HUDDERSFIELD

DESIGN & ACCESS STATEMENT ADDENDUM

SEPTEMBER 2024

Fig. 2.1.2 Amended Museum and Art Gallery Use Plan

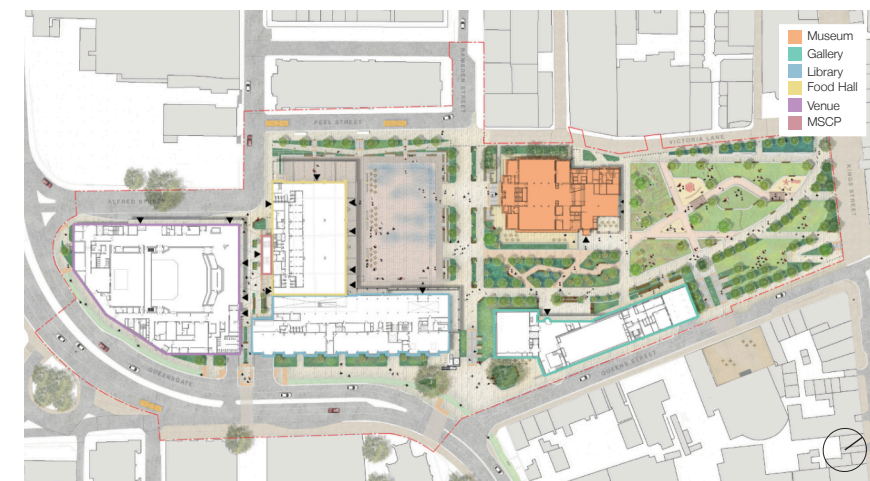
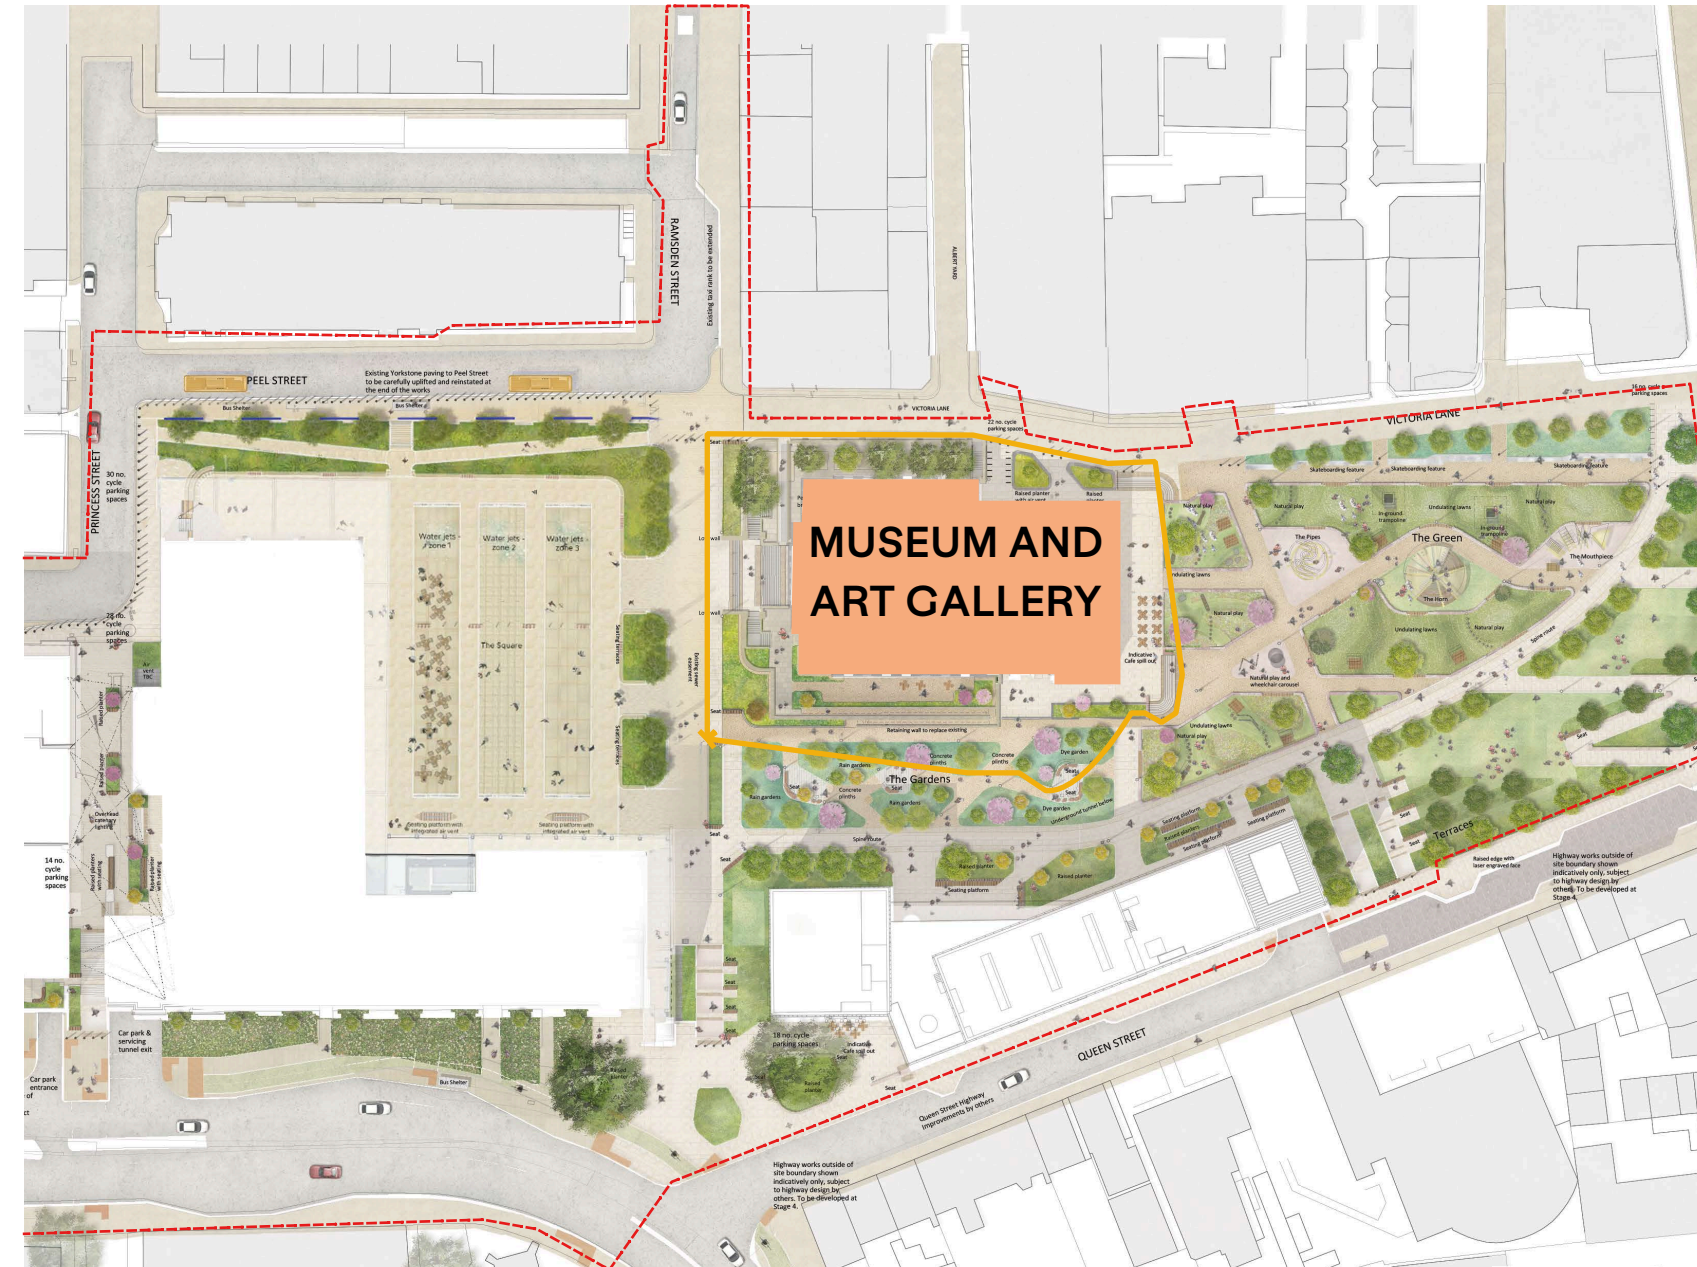
The uses of the combined Museum and Art Gallery will share services within the building and all be under the same use class F1. The proposal follows the same principles of remodelling the existing grade II listed building, alongside areas of demolition to provide a new extension to the north. As before, the principles of refurbishment to the listed building are largely maintained, and are subject to a listed building consent application, submitted in parallel with this amended planning application and described in further detail in the heritage section.

The proposed Museum and Gallery will have a GEA of 6617 sqm, of which 2828sqm is within a new extension, which spans from basement to roof level.

Fig. 2.2.2 Amended Proposals - Basement Floor Plan

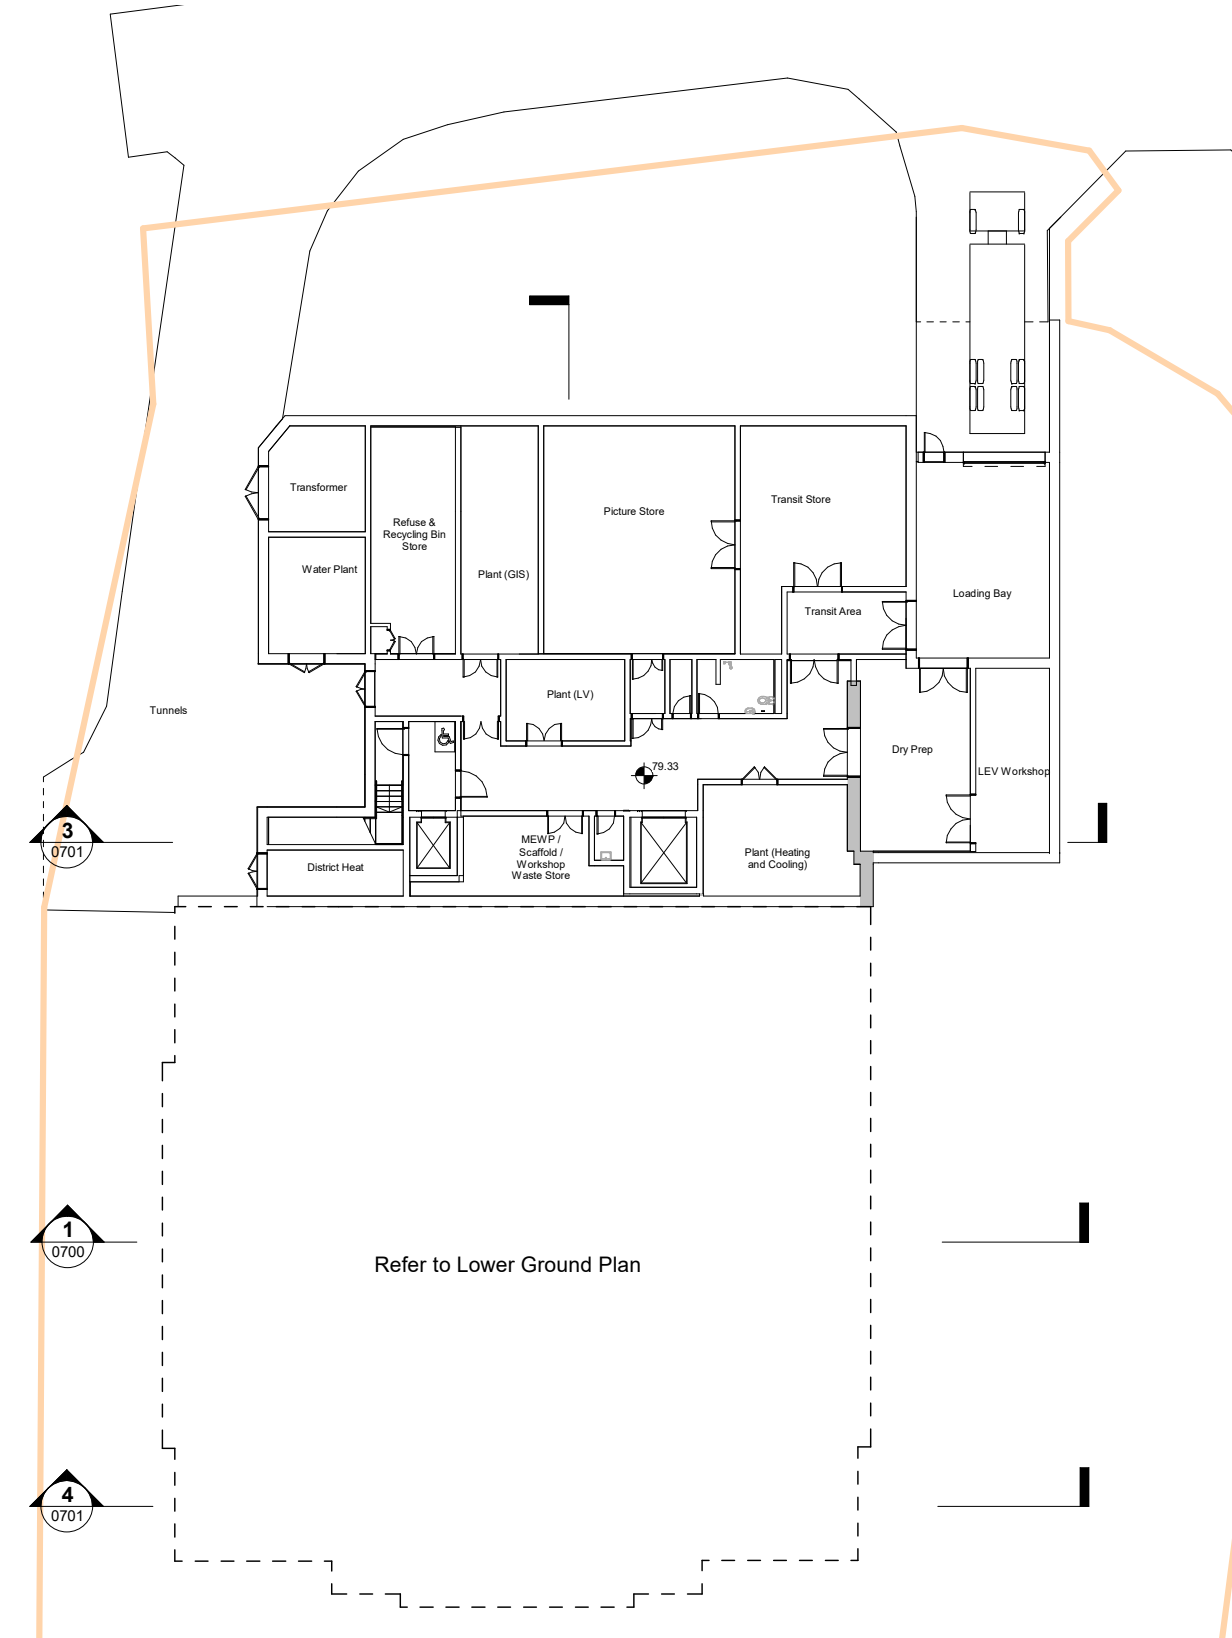
The structural retaining wall strategy for the basement has been reviewed and updated, this has lead to the south wall moving approximately 1.7m north to avoid complex intersections with the existing foundations to the south. To avoid loosing area to the basement, the north wall has also moved north by 1.7m, however the upper floors remain in the same location as the previous application.

To provide more efficient use of front of house space on upper floors, the number of new stairs has been reduced to one stair that serves all floors of the new and existing building. To enable this to work efficiently this has been relocated to the west of the plan into the existing tunnels whilst still enabling the turning head to function for third party use.

Due to the shift in stair position, the lift locations have been adjusted to suit, with a passenger / fire fighting lift adjacent to the stair, alongside a goods lift to serve all floors. These amendments have lead to a change in room locations creating a more efficient and functional use of space.

Fig. 2.2.3 Amended Proposals - Lower Ground Floor Plan

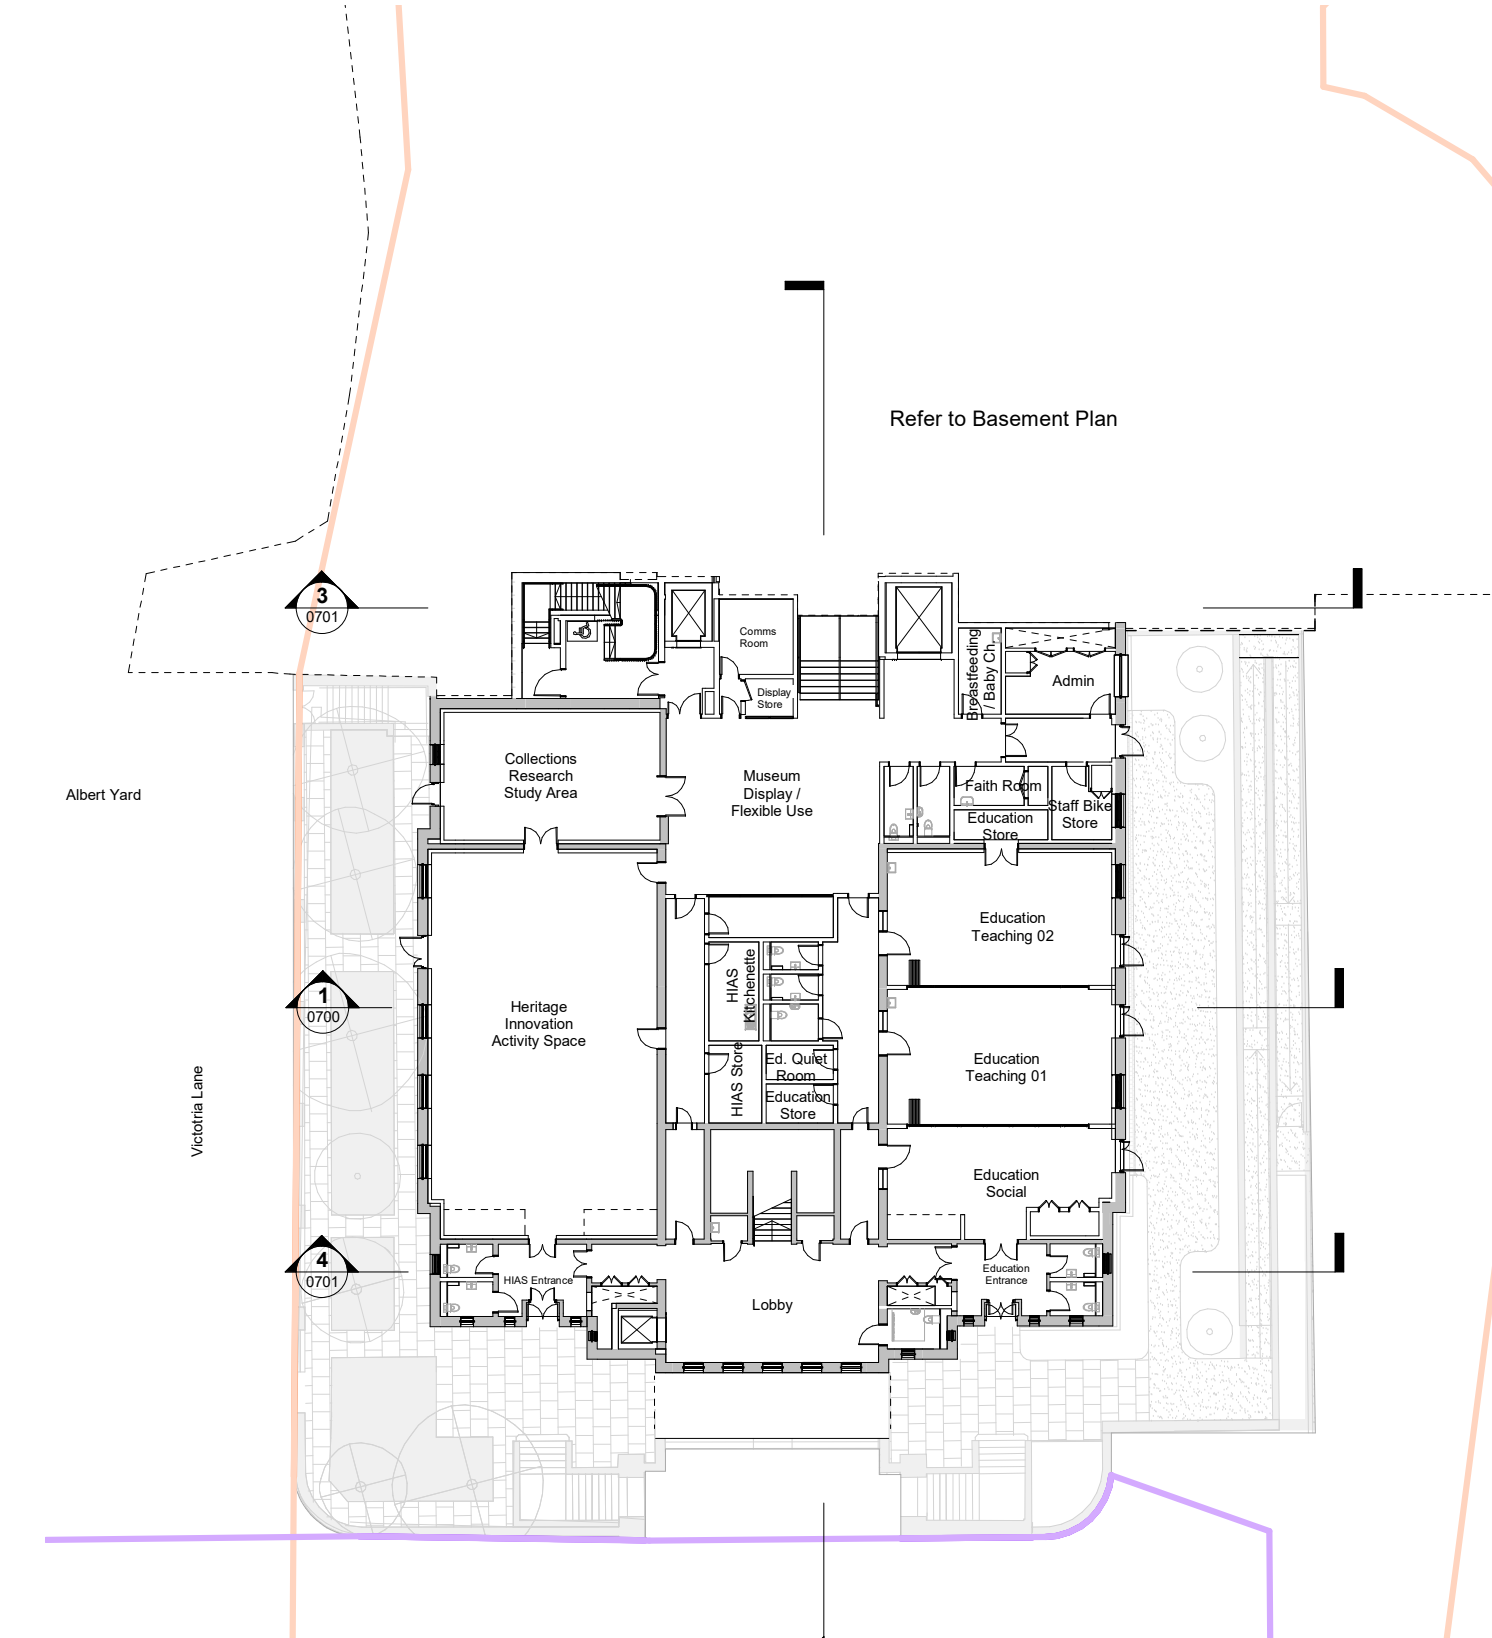
The west of the plan has now been changed from Staff admin space to Heritage Innovation Activity Space (HIAS), a flexible event space with direct connection to the western sunken terrace area. The admin spaces are now dispersed across all floors providing a more localised connection to the different uses.

To provide a more public use of the lower ground floor outside the hire spaces, the feature stair has been widened in the centre of the plan, and the display stores have been reduced to provide an addition display space and direct connection to the new entrance to the north. This has also allowed for secondary back of house routes and rooms to serve the education and HIAS Space.

It is envisaged that the existing southern doors to the lower ground level will be available for direct and out of hours access to the HIAS and education space, and the new landscape scheme enables step free external access to these areas.

Fig. 2.2.4 Amended Proposals - Upper Ground Floor Plan

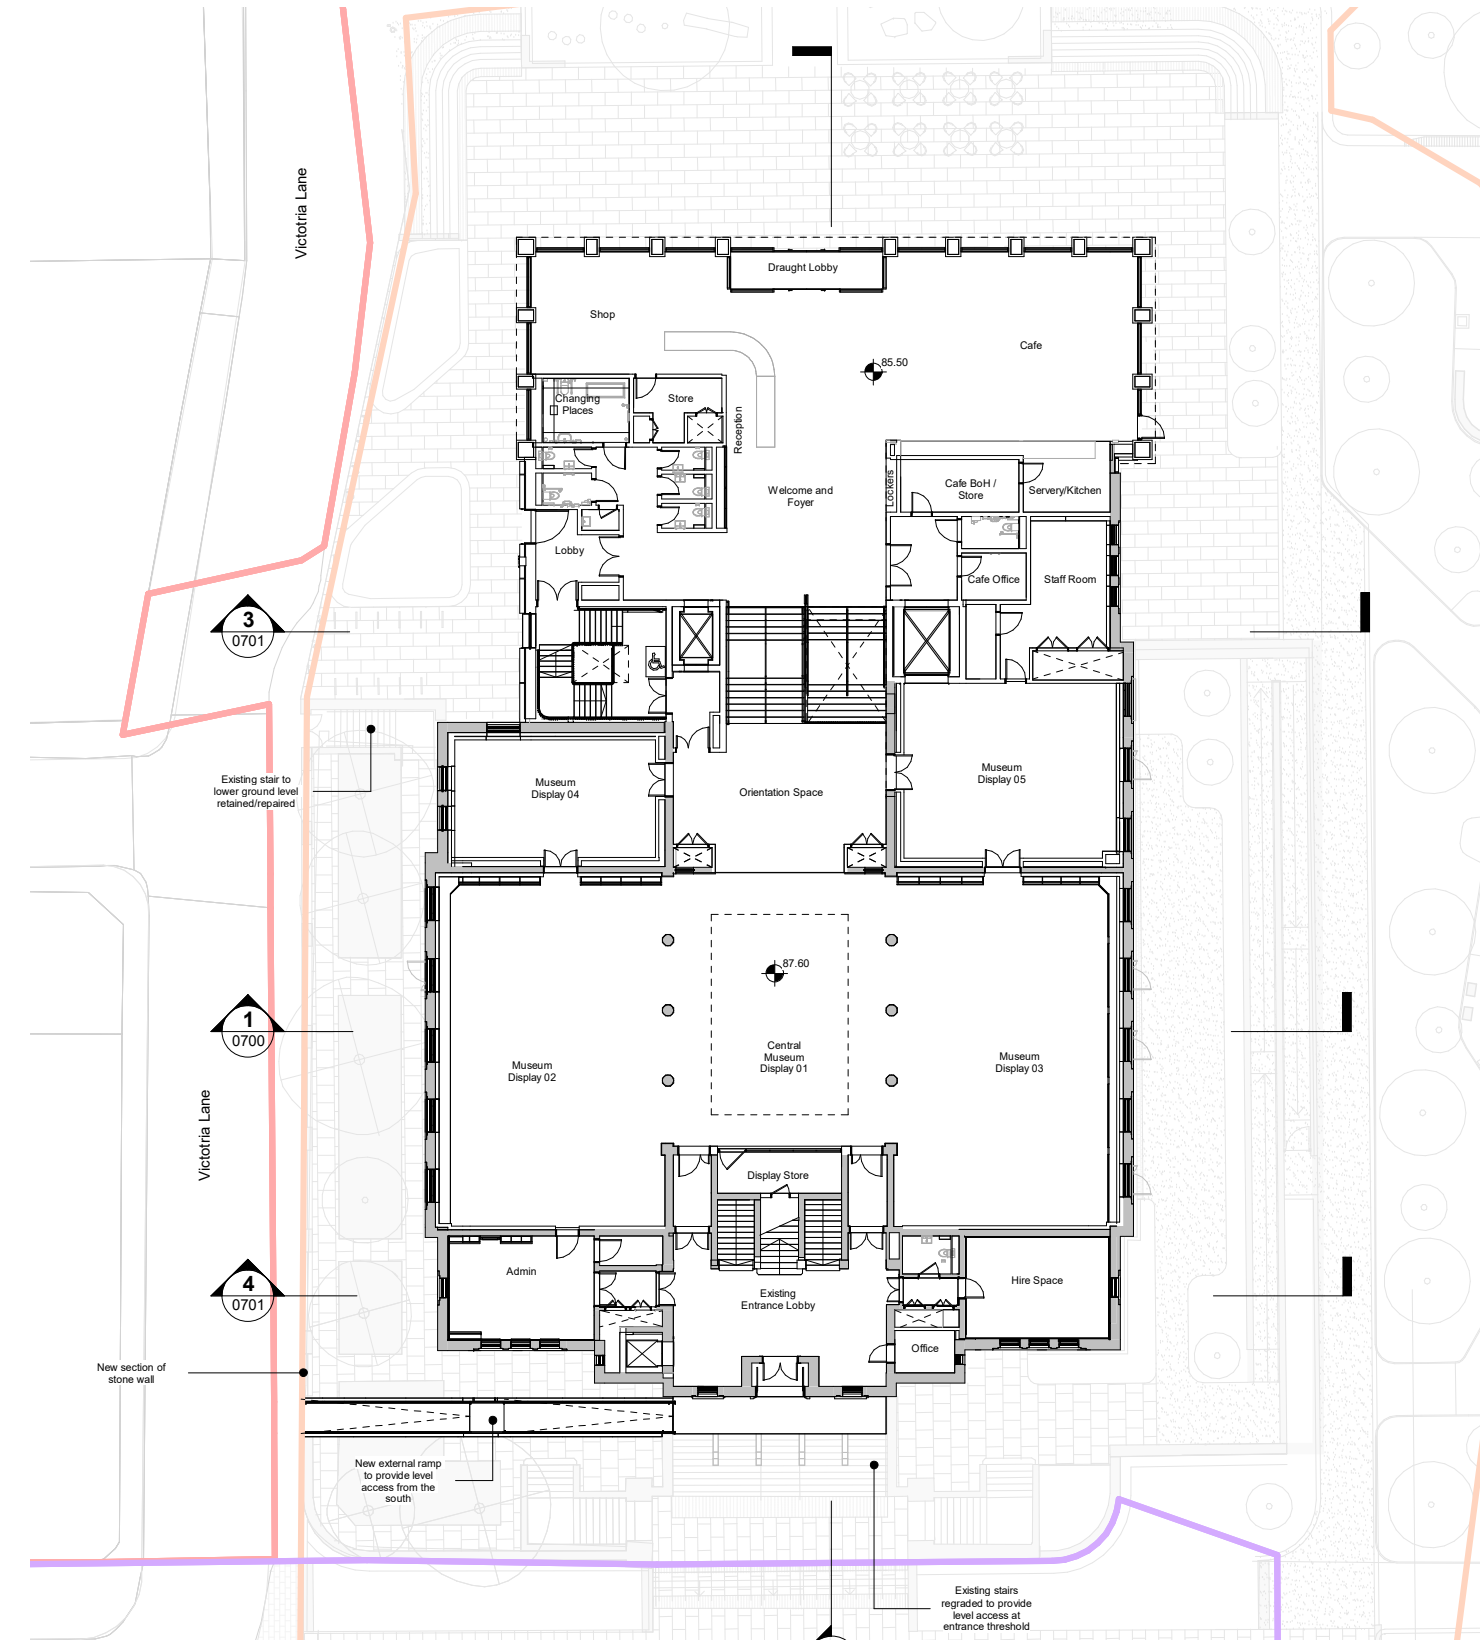
The main changes on these levels have been to the north of the proposal. The previous scheme's new entrance was located to the east, adapting the existing facade. Due to the change in brief and masterplan, the entrance has been relocated to the north of the building, creating a stronger axis to the existing southern entrance alongside direct connections to the new northern landscape within the later phases. This shift reduces intervention and retains the nearly full extent of the existing east facade.

The change to the vertical circulation has removed a stair core previously to the north west, increasing active frontage and visibility. Whilst the relocation of the circulation core from the east has enabled greater retention of the existing eastern room extents, transformed to a Museum Display space.

Due to the need for increased Museum and Art Gallery space, the main feature stair has been reviewed to create a more efficient use of space whilst meeting the ambitions of the brief. The feature stair now serves the lower ground and both upper ground levels (existing and new build), alongside increased in width to provide better visibility and access between these floors. The atrium void has been amended in proportion whilst continuing to span across all floors with a roof light above providing daylight throughout the space.
